DSO9104A-03

SERVICE NOTE

DSO9104A - 1GHz Digital Signal Oscilloscope

Repair for Windows "Power surge on hub" message

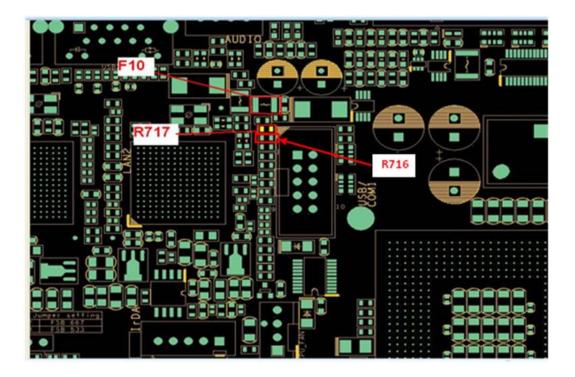
- 1. Refer to the service manual to remove the motherboard from the scope.
- 2. Install the three components from the upgrade kit on the motherboard. Refer to the below drawing and the drawing on the next page for component locations. The 0960-2789 motherboard is RoHS compliant and the below three components are also RoHS compliant. You should use a RoHS soldering station and RoHS solder techniques when possible.

F10 – 0837-3854 Thermistor

R717 - 0699-7654 10K Resistor

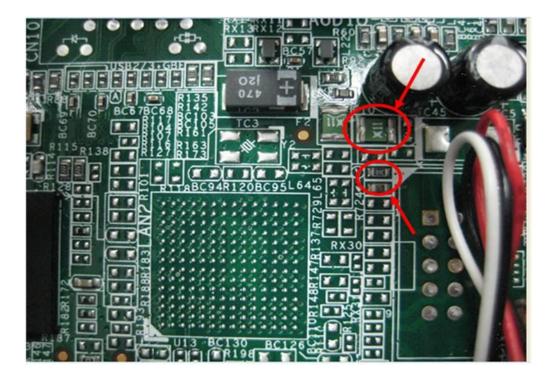
R716 - 0699-5789 15K resistor
